PROPOSED NEW - GAS STATION

18701 NORTHLINE RD

Special Condition and Site Plan Review

City of Southgate, Michigan

PROP. SITE PLAN
 SCALE : 1" = 15'-0"

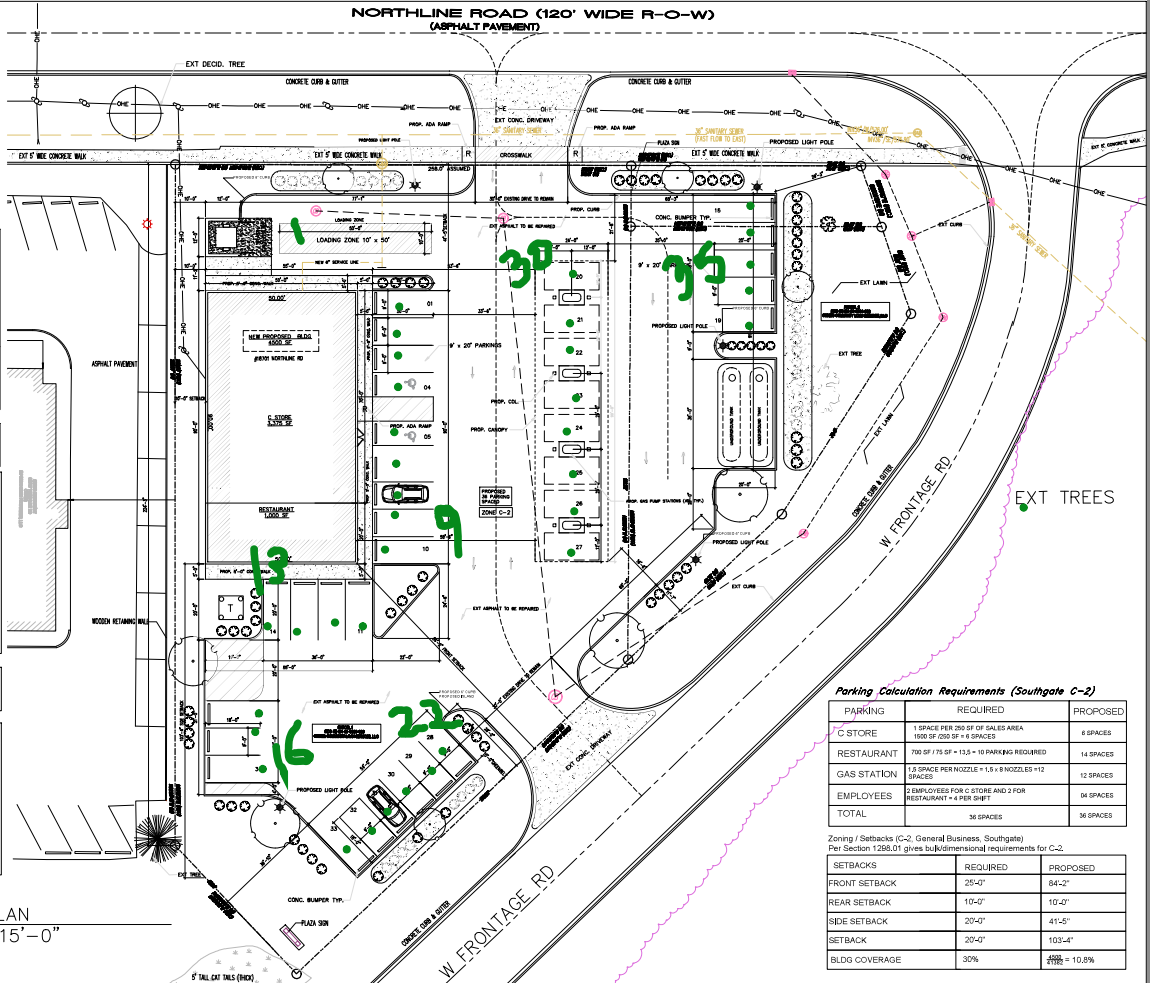
1. Thirty-five (35) spaces are counted on sheet SP-101 whereas the parking calculation table proposes thirty-six (36) spaces.
2. The restaurant calculation for parking is as follows “700 SF/75 SF = 13.5 = 10 parking required.” This should be corrected to “700 SF/75 SF = 9.33 spaces.” We ask the applicant to confirm if 14 spaces are still proposed, or if the number will be reduced based on the new calculation.
3. The parking space directly south of the ADA space # 5, appears to have a greater width than the rest of the proposed spaces. We ask the applicant to clarify if the width will be reduced.

Section 1292.03 requires maneuvering lane width for 90-degree parking to measure at least twenty-two (22) feet. Current plans exceed this requirement, showing measurements of thirty-three (33) and thirty-five (35) feet. Parking space dimensions have also been provided and vary throughout the site. The parking area in front of the building and northeast corner show dimensions of 9x20 feet, which will need to be increased to 10x20 feet. The parking area on the southwest corner shows dimensions of 9x18 feet, which will need to be increased to at least 10x19 feet.

Items to be Addressed: 1) Address parking discrepancies #1-3. 2) Revise parking space dimensions to meet ordinance requirements. 3) Clarify timing and frequency of deliveries.

PROP. PHOTOMETRIC PLAN
SCALE : NA

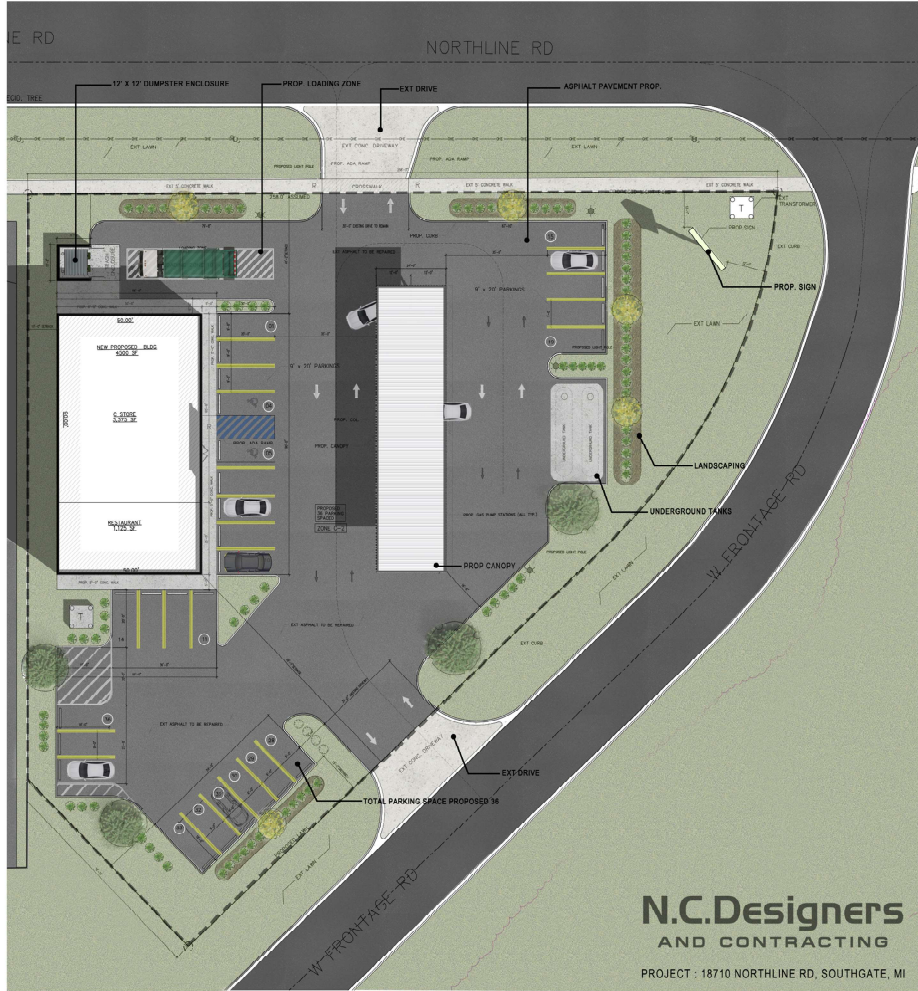
A lighting/photometric plan has been provided on sheet SP-104. Proposed lighting includes both four (4) building mounted fixtures, sixteen (16) gas station canopy mounted fixtures, and six (6) freestanding light poles arranged evenly throughout the site with a height of eighteen (18) feet, meeting ordinance requirements. All lighting fixtures are also shown to be down shielded.

Photometric measurements indicate the maximum light level at the property line as a result of site lighting will be 3.2 footcandles, located at the southern entrance. Lighting levels on the remaining property lines do not exceed 1 footcandle. Due to the non-residential uses surrounding the property, we are of the opinion that proposed lighting will not have an adverse effect on adjacent properties.

PLANTING TREES & SHRUBS

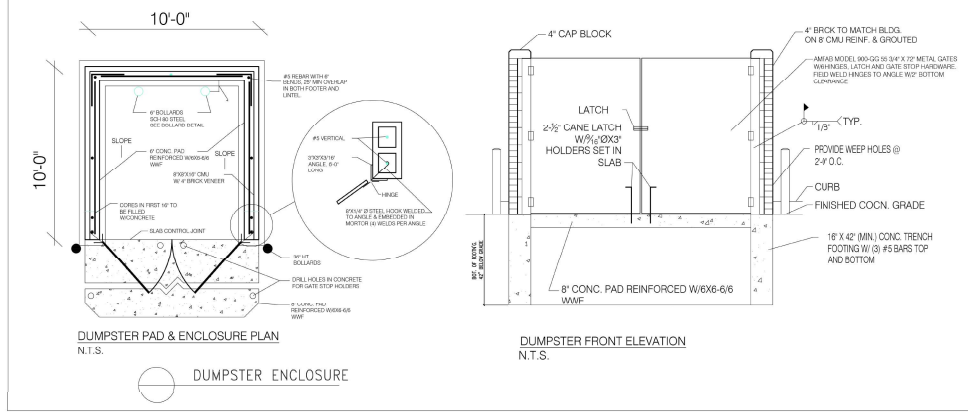
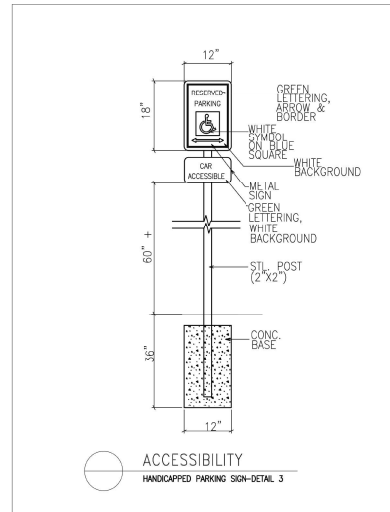
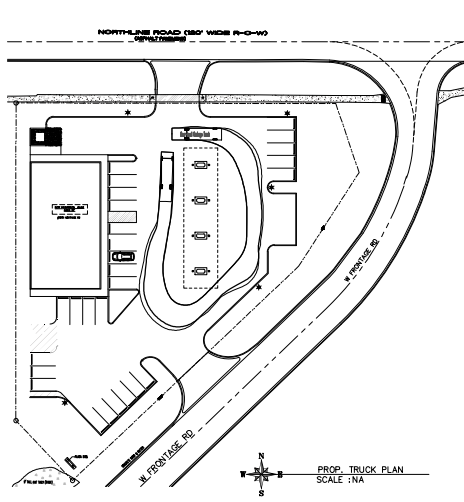
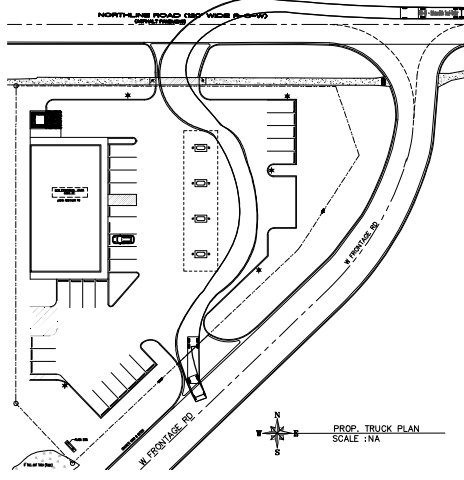
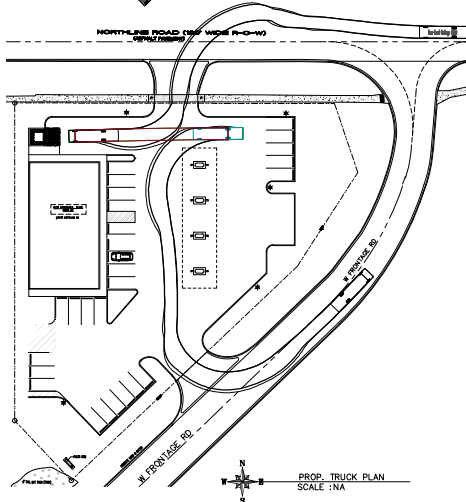
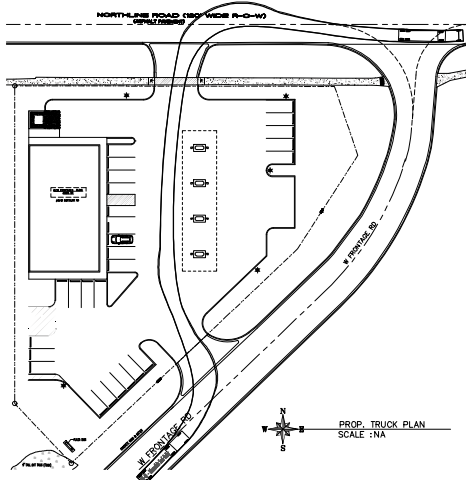
A landscape plan has been provided on sheet SP-102, with details on sheet SP-103. We do note on sheet SP-103, note 1, there is mention of compliance for Northville, Michigan. This will need to be revised to the City of Southgate.

Per section 1298.09, a landscape plan shall also consist of planting cross-section details, planting size, and spacing dimensions, which are provided on the current landscape plan on sheet SP-103 except for a shrub detail which should be provided. Planting symbols, quantities, size, and spacing information are provided. While the minimum ordinance requirements for shrub spacing is three (3) feet, we are of the opinion that the current spacing of two (2) feet is adequate after consultation with a landscape architect.

Items to be Addressed: 1) Change note #1 from “Northville” to “Southgate” 2) Provide shrub planting detail.

Sheet Title:
ELEVATION

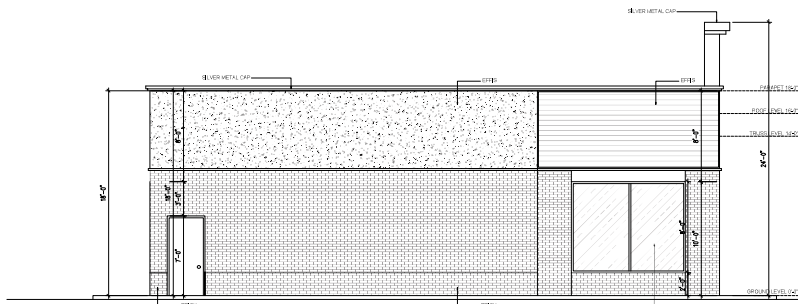
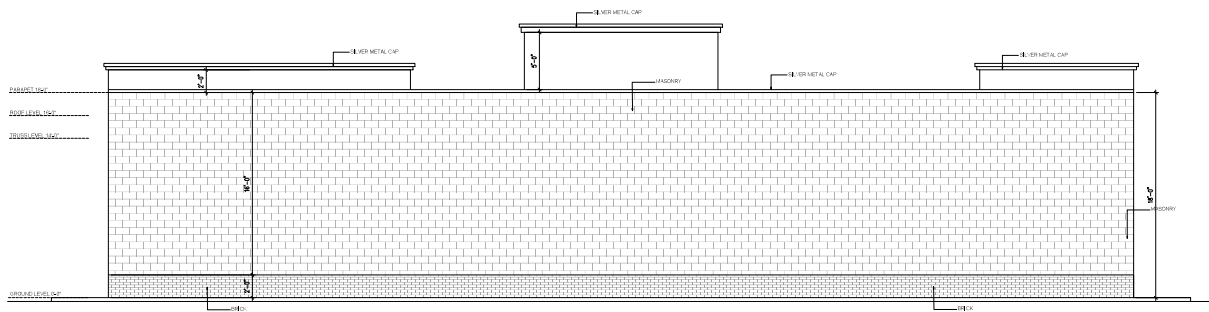
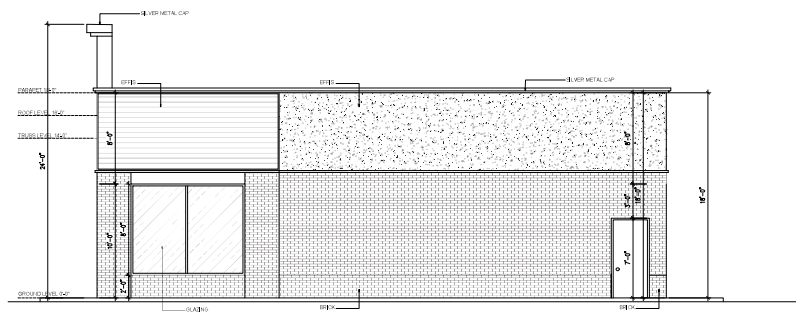
**As provided by section 1298.01(i), no interior side yard setbacks are required when a building wall has no openings. Building elevations on sheet A-103 indicate the western building elevation will have zero openings.
